NOISE WHEN ADJUSTING THE STEERING COLUMN UP OR DOWN

This Service Information bulletin replaces SI B32 01 15 dated July 2015

F15 (X5)	F16 (X6)	F85 (X5 M)	F86 (X6 M)
----------	----------	------------	------------

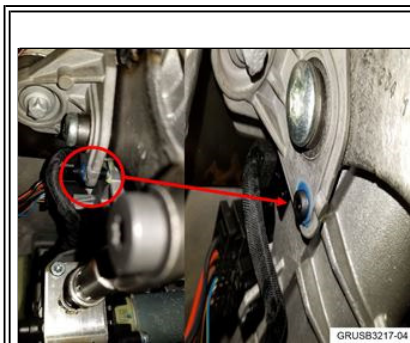
Verify if the noise occurs when raising or lowering the steering column position.

1. Remove the steering column shroud as per the repair instruction RA 32 31 020, Removing and installing lower section of steering column shroud
2. Adjust the steering column position up and down and check if the noise is present.
 - a. If the noise does not continue with the shroud removed, reinstall the upper and lower shroud sections and repair as necessary (adjust the proper position of the shroud)
 - b. If the noise continues, proceed to step 3

3.  Remove the plastic screw (Torx T20)

<p> Note:</p> <p>UPDATE! If the screw snaps unexpectedly, the screw must be sheared off in the designated area with a suitable tool</p>
---	---
